**Freightliner  
Service Bulletin**

**Description of Revisions:** *This replaces the version dated February 2009; two more crossover part numbers are added to [Table 2](#).*

## Adapting Jiffy-tite Replacement Radiators to QLD-Equipped Vehicles

## Adapting QLD-Equipped Transmission Oil Cooler Lines to a JIC-Equipped Radiator

**Fig. 1, QLD-to-JIC Adapter, p/n GT 7213 0003**

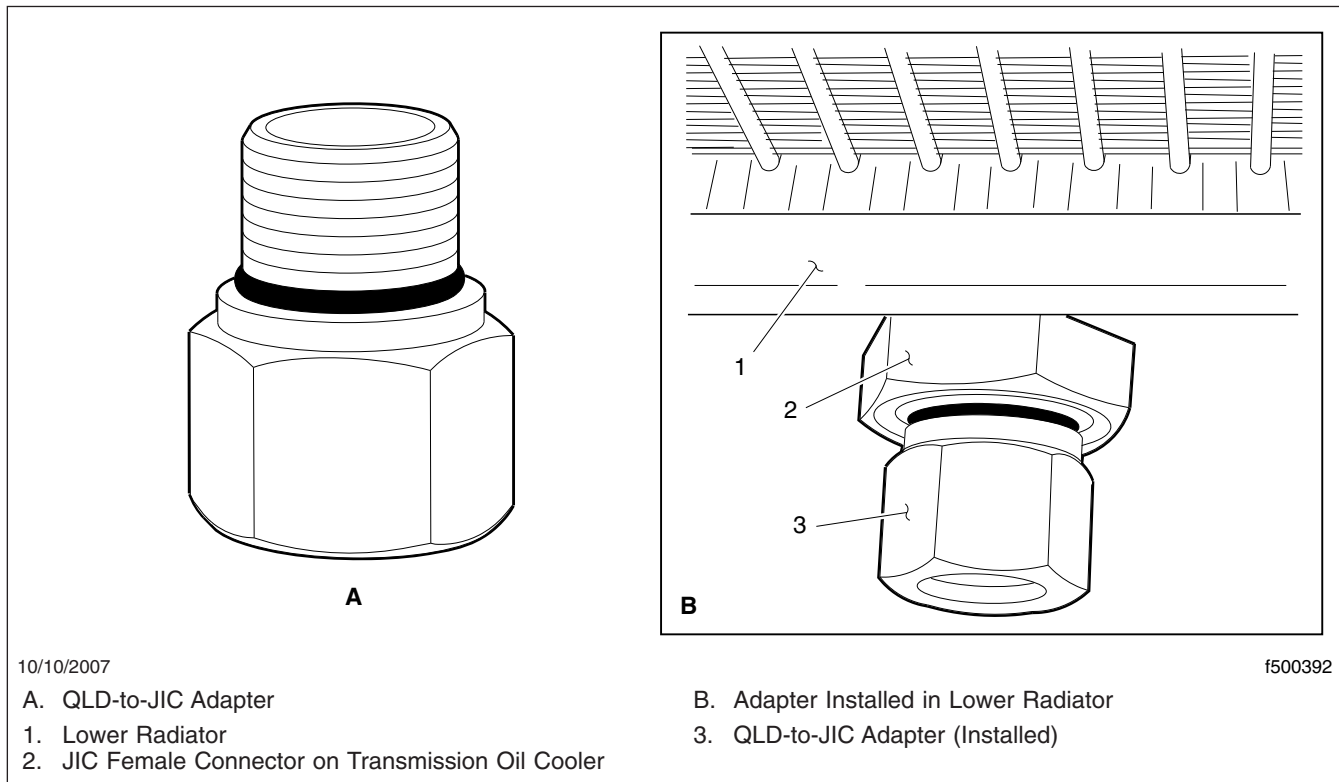
To replace a radiator having QLD connectors with a JIC-equipped radiator, order two adapters, p/n GT 7213 0003 (see [Fig. 1](#)), and install them on the radiator so that the existing QLD lines can attach. Tighten them 53 lbf·ft (72 N·m).

The adapter connectors are installed only at the radiator; the original QLD transmission oil cooler lines continue to be used.
